**FIGURE R3.11.2-2b**  
Existing P.M. Peak-Hour Traffic Volumes

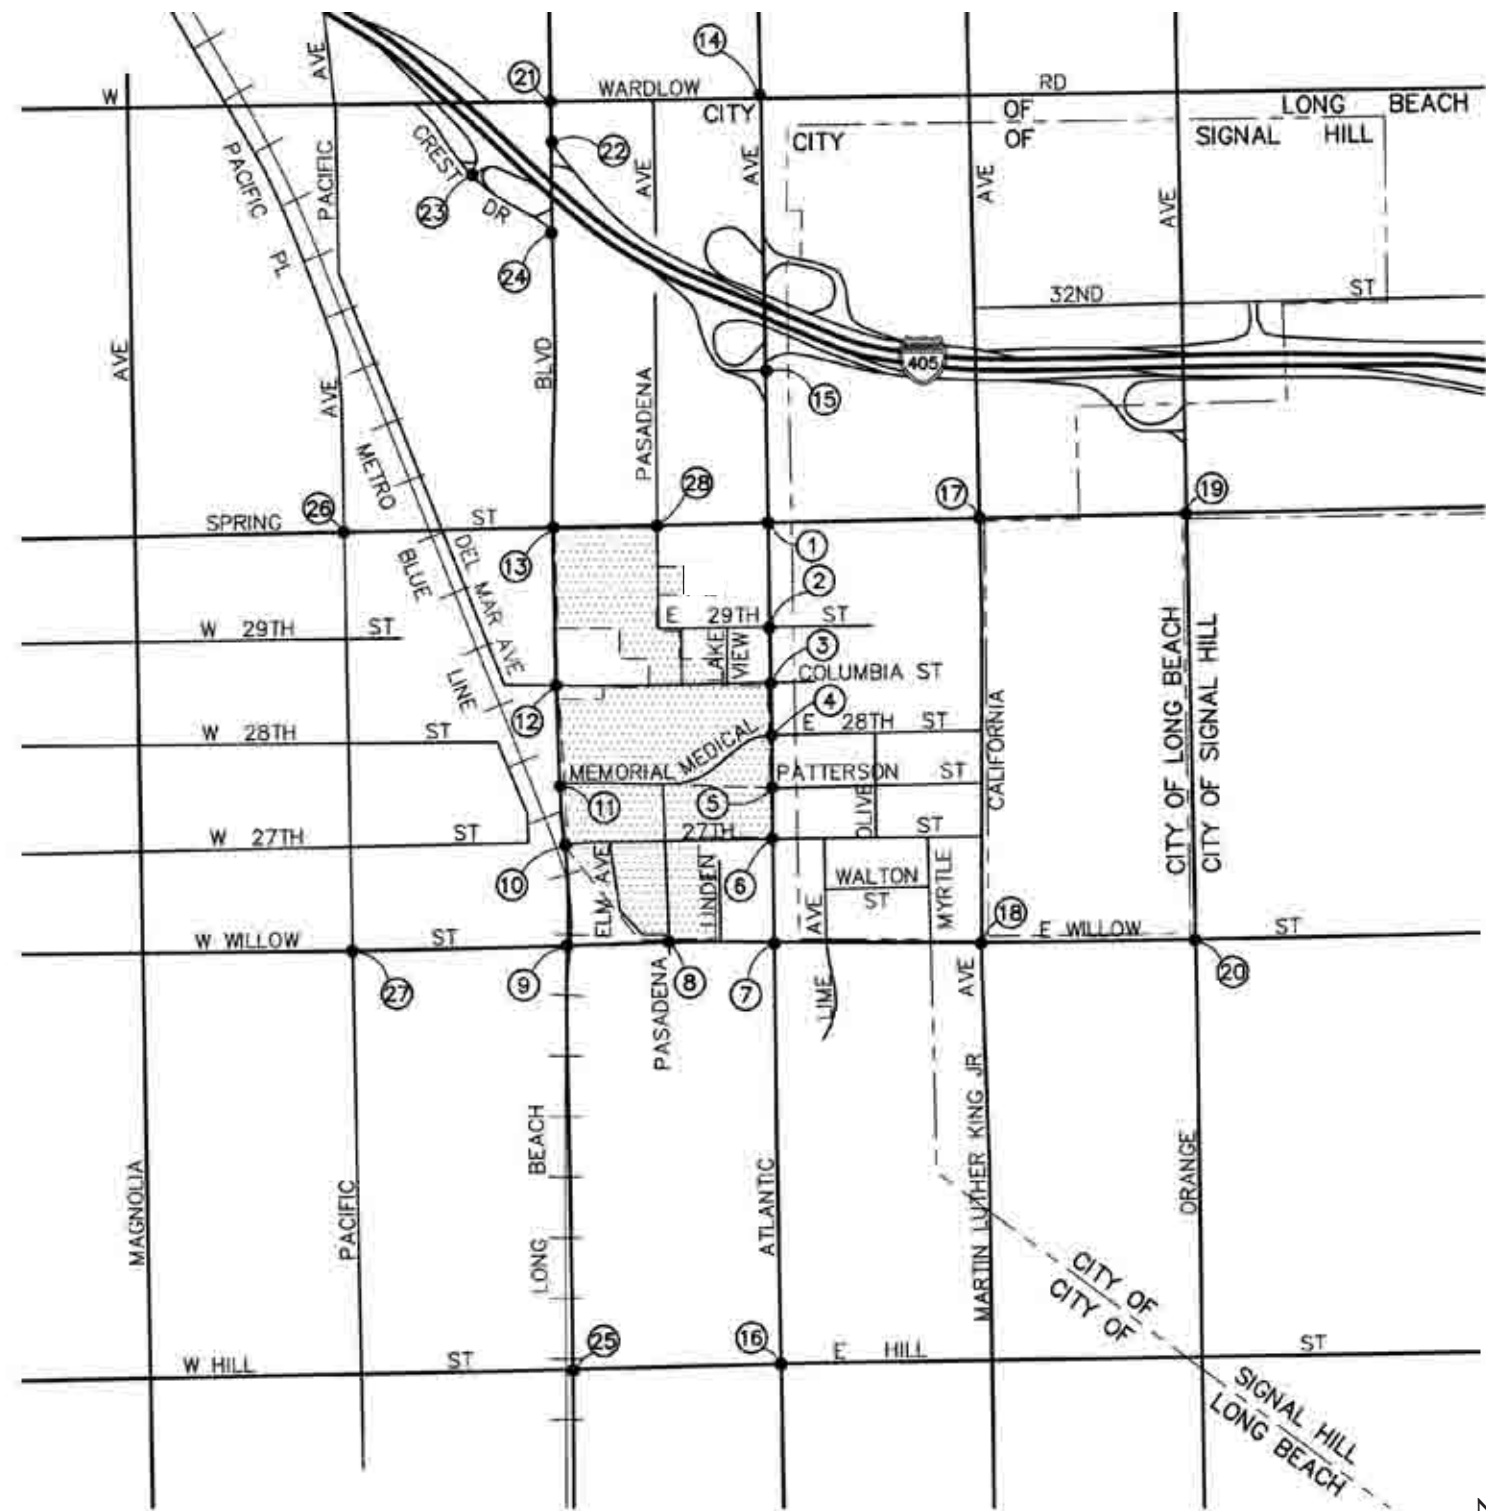
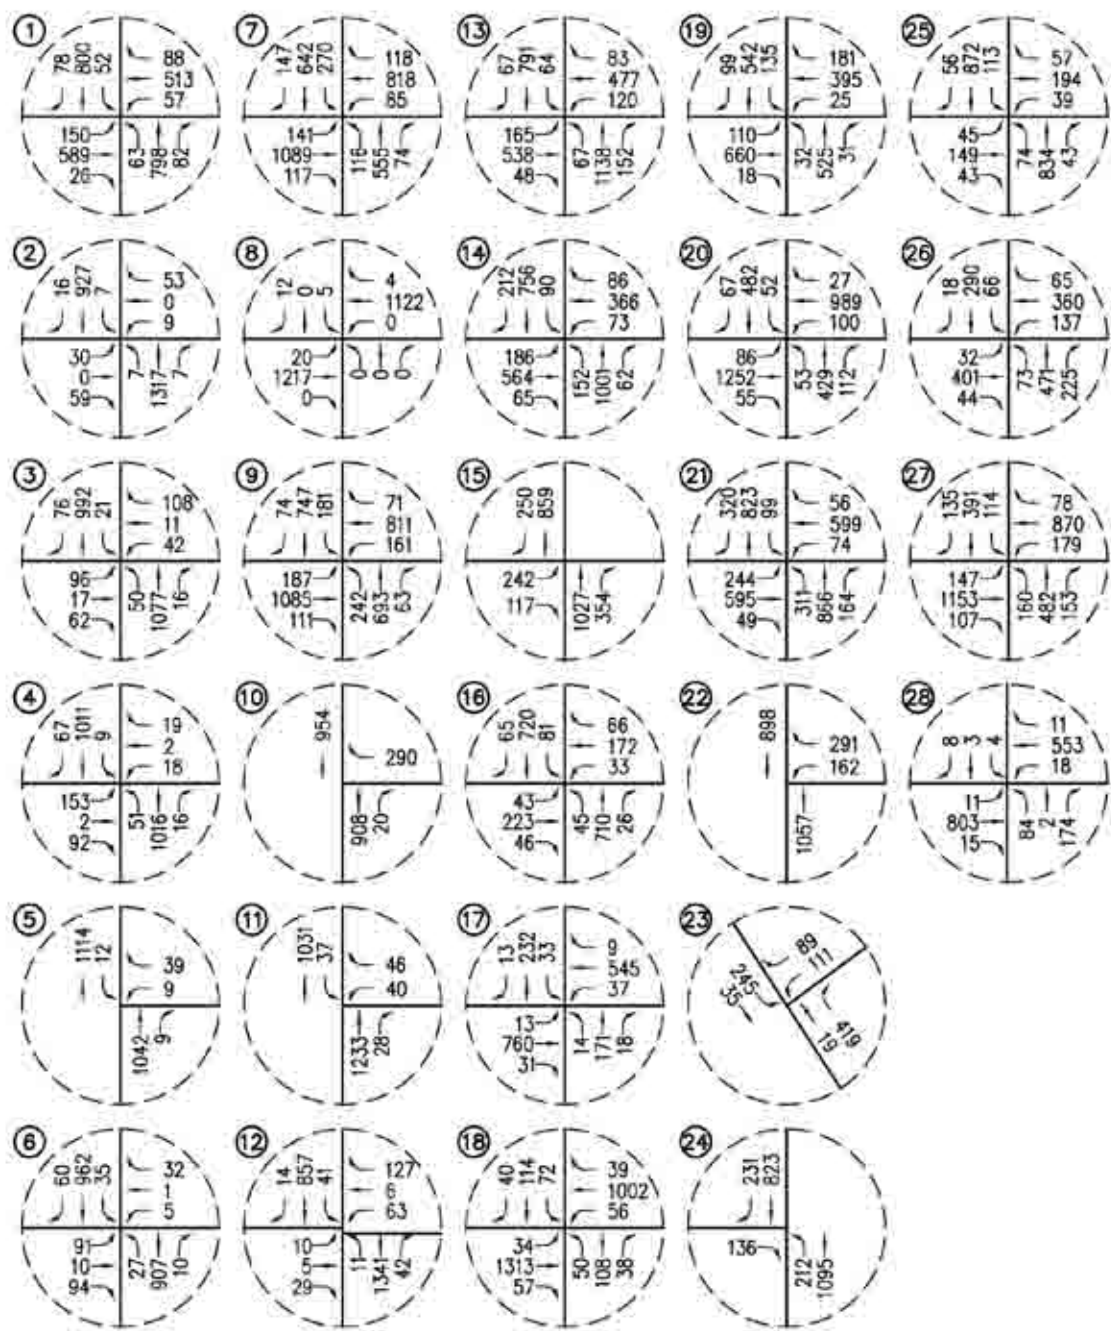
Page 3.11-4 The northeastern boundary of the Campus was revised in Figure 3.11.2-2B and replaced by Figure R3.11.2-2B.

In the last sentence of the second paragraph under this heading, please replace the reference to (Figure 3.11.2-2B, *Existing P.M. Peak-Hour Traffic Volumes*) with the following:

(Figure R3.11.2-2B, *Existing P.M. Peak-Hour Traffic Volumes*)

**FIGURE R3.12.2-1**  
Existing Sanitary Sewer, Storm Drain, and Water Lines in the Proposed Project Vicinity

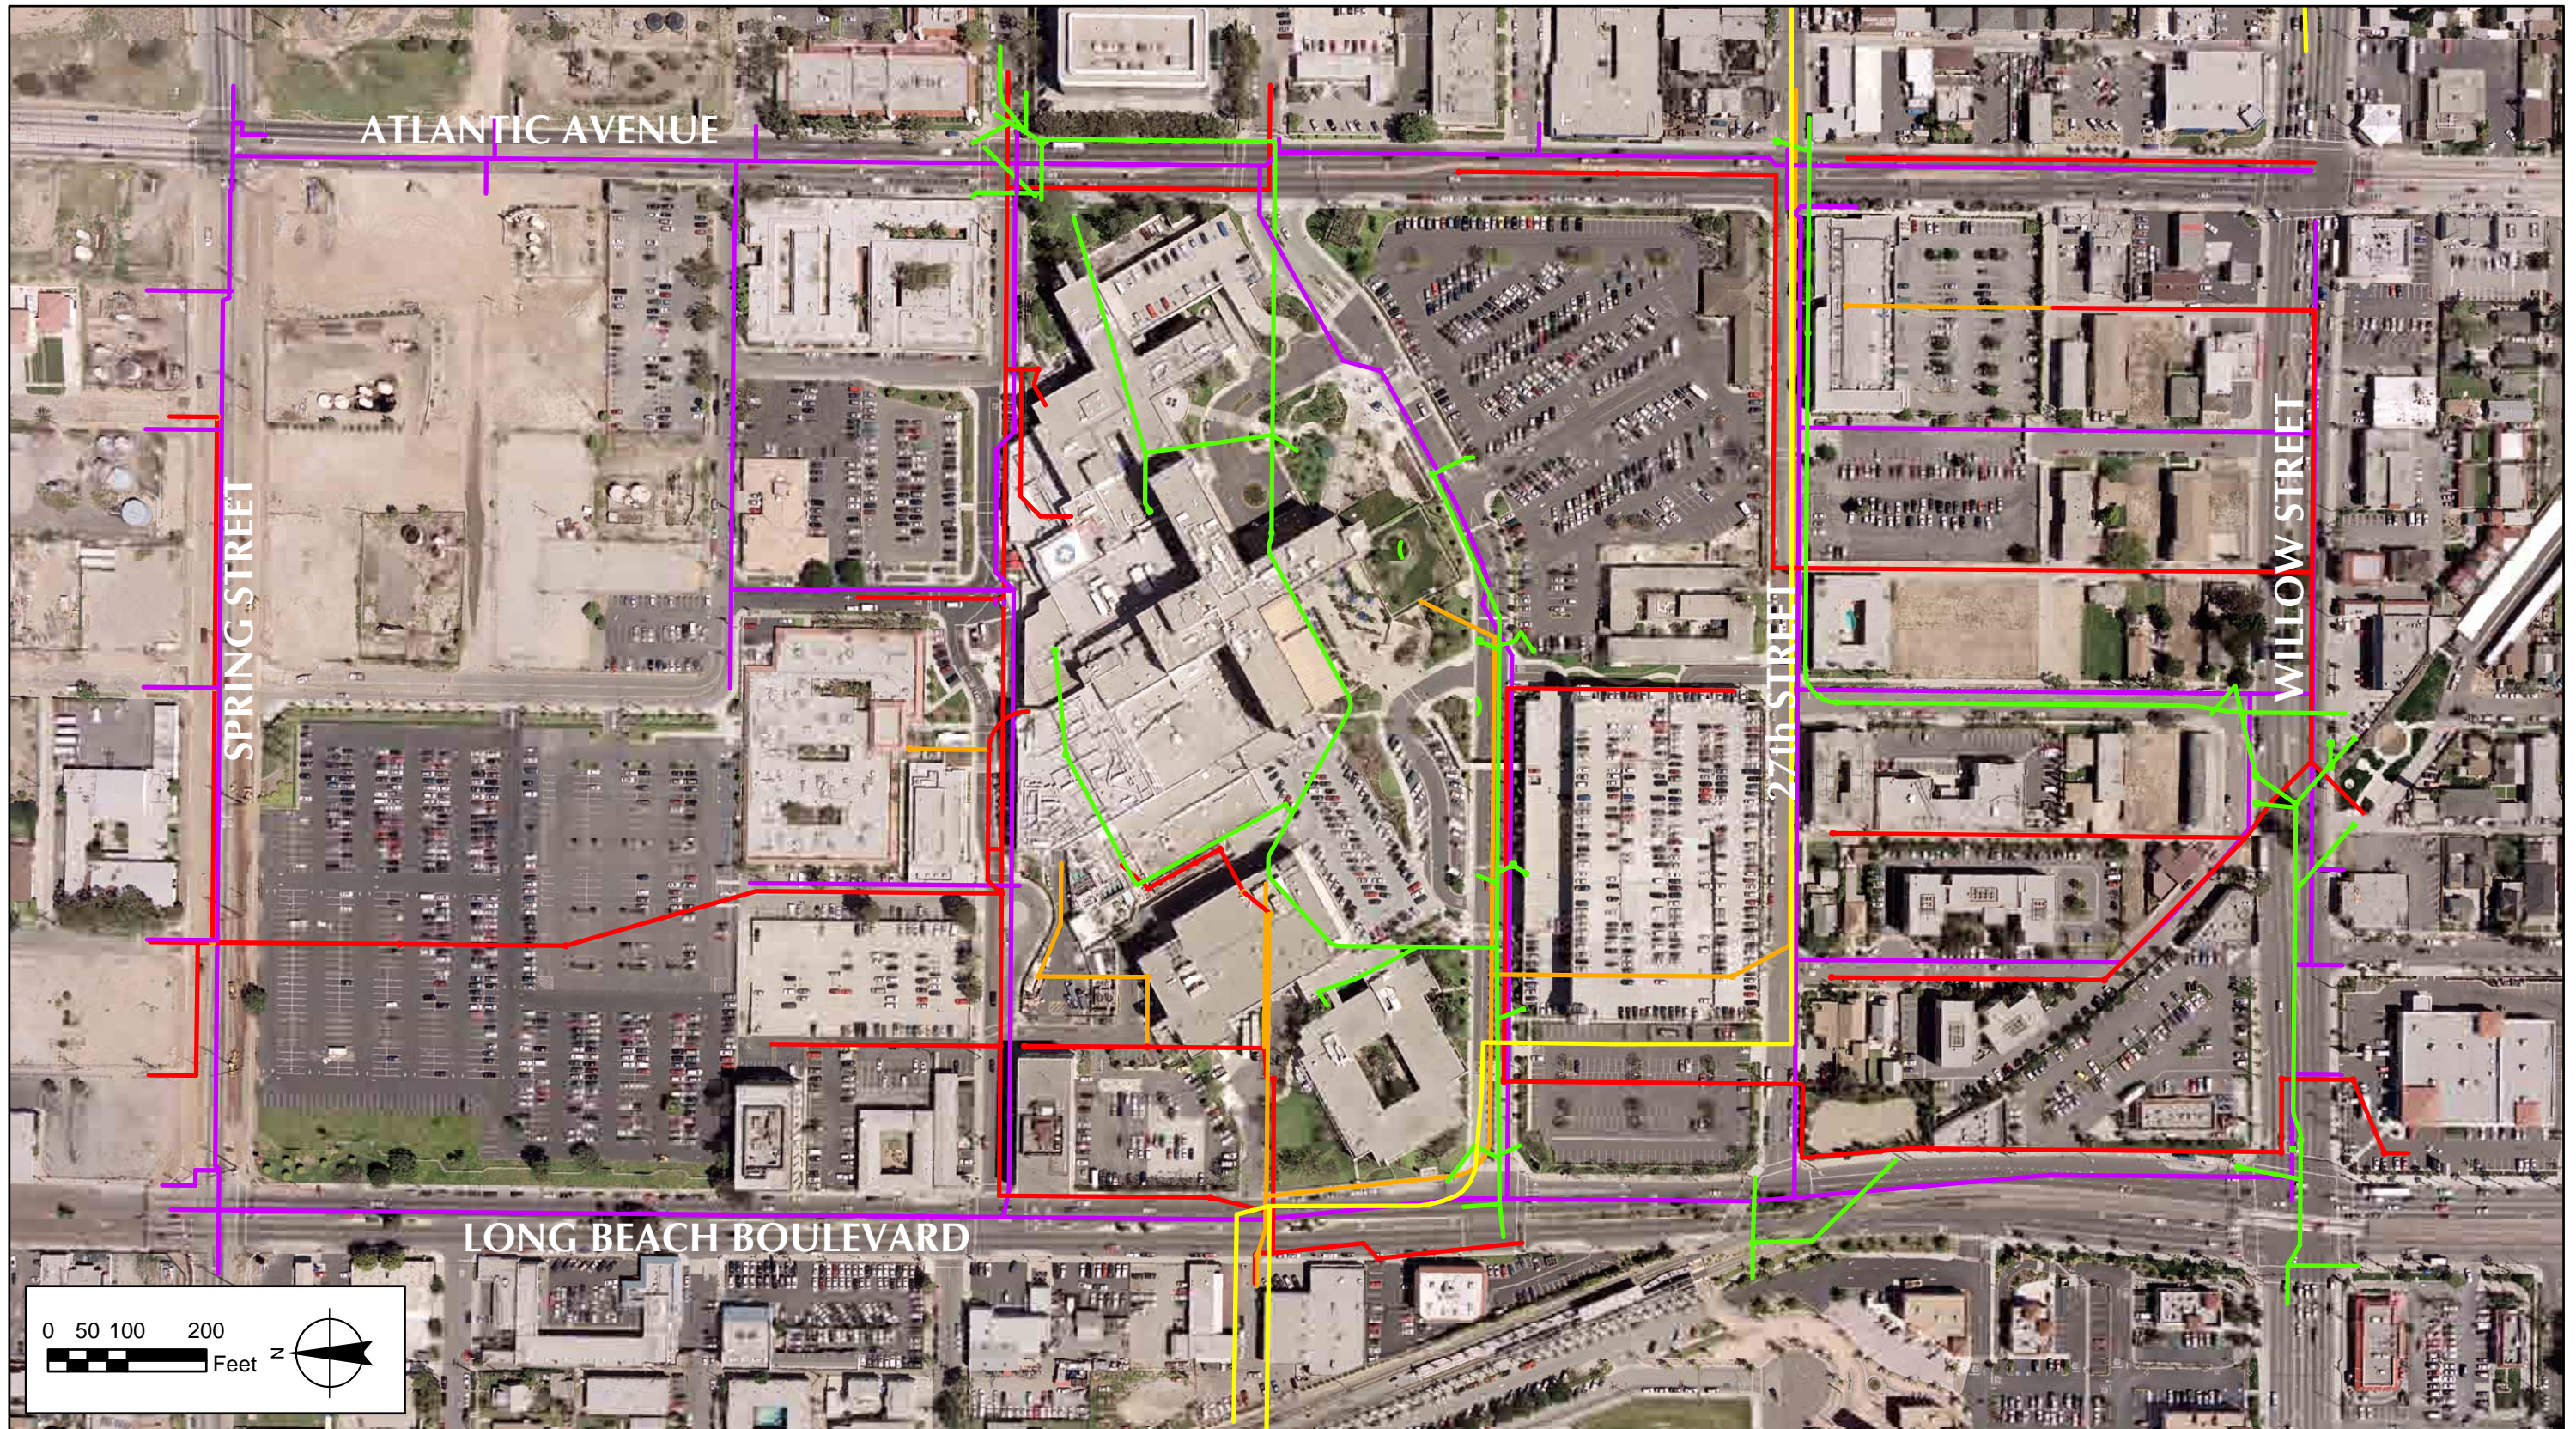
Page 3.12-4 In the first sentence of the first paragraph under this heading, please replace the reference to (Figure 3.12.2-1, *Existing Sanitary Sewer, Storm Drain, and Water Lines in the Proposed Project Vicinity*) with the following:

(Figure R3.12.2-1, *Existing Sanitary Sewer, Storm Drain, and Water Lines in the Proposed Project Vicinity*)

**FIGURE R4.1-1**  
No Project Alternative

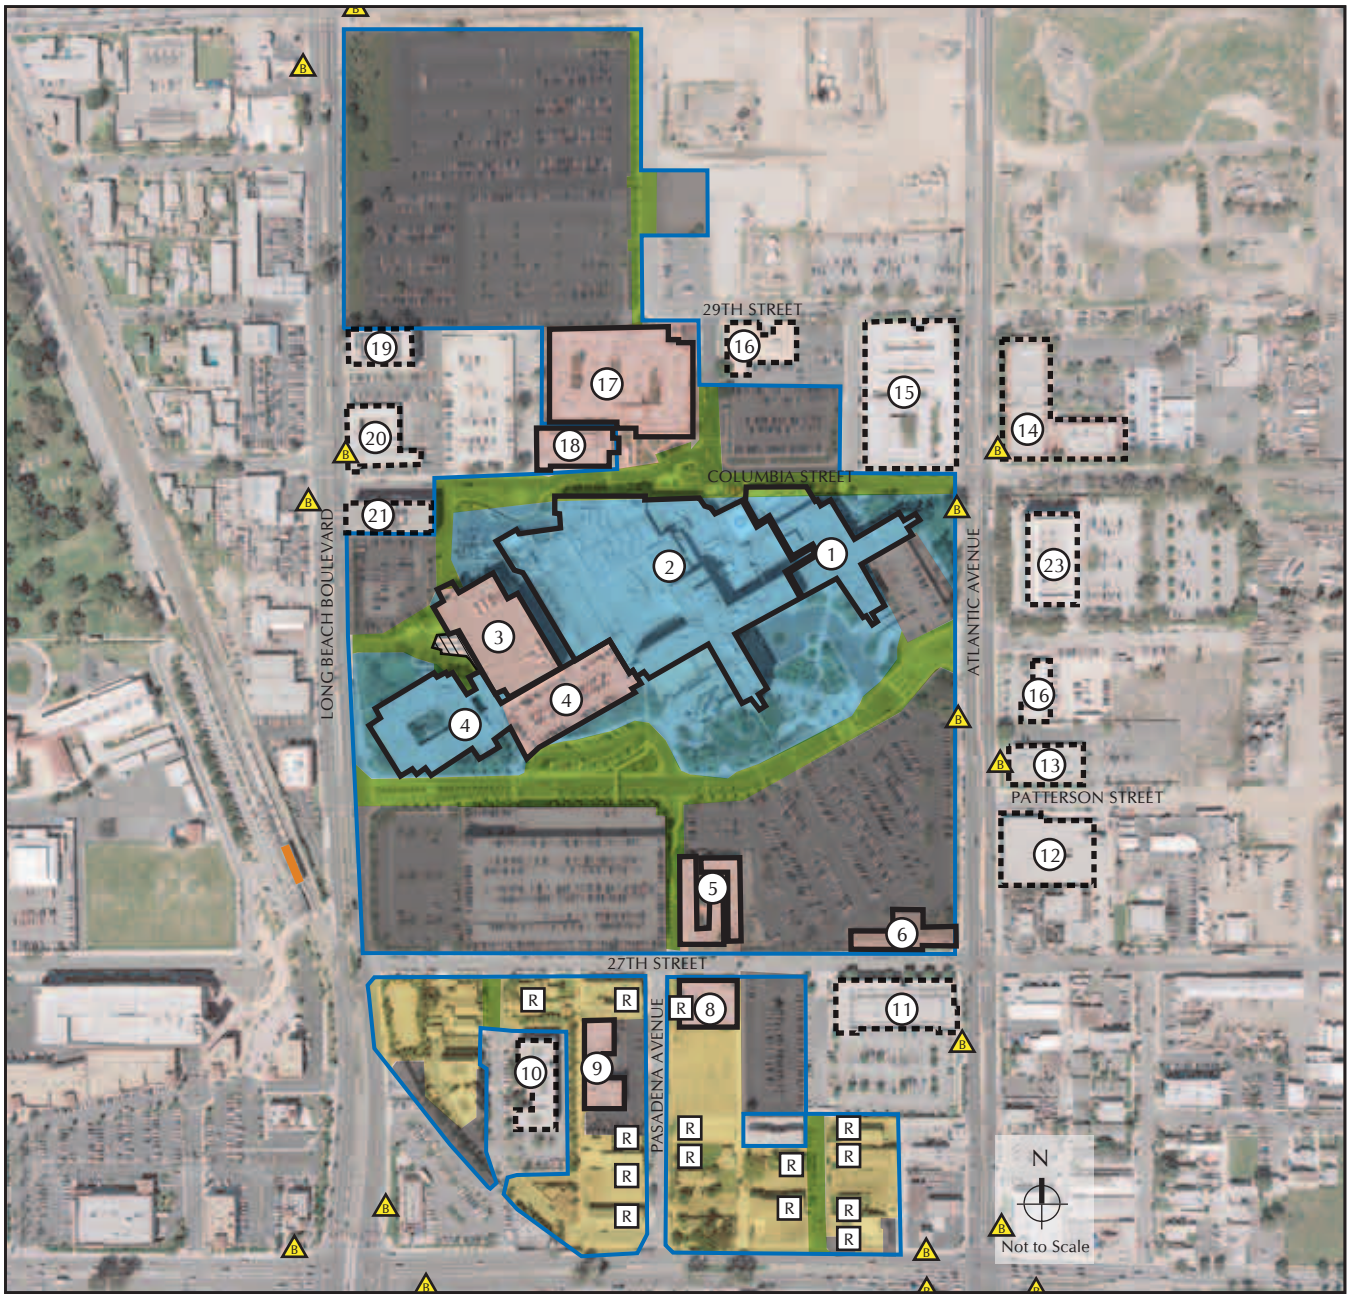
Page 4-5 The northeastern boundary of the Campus and the location of the central plant building were revised in Figure 4.1-1 and replaced by Figure R4.1-1.

In the first sentence of the first paragraph under this heading, please replace the reference to (Figure 4.1-1, *No Project Alternative*) with the following:

(Figure R4.1-1, *No Project Alternative*)
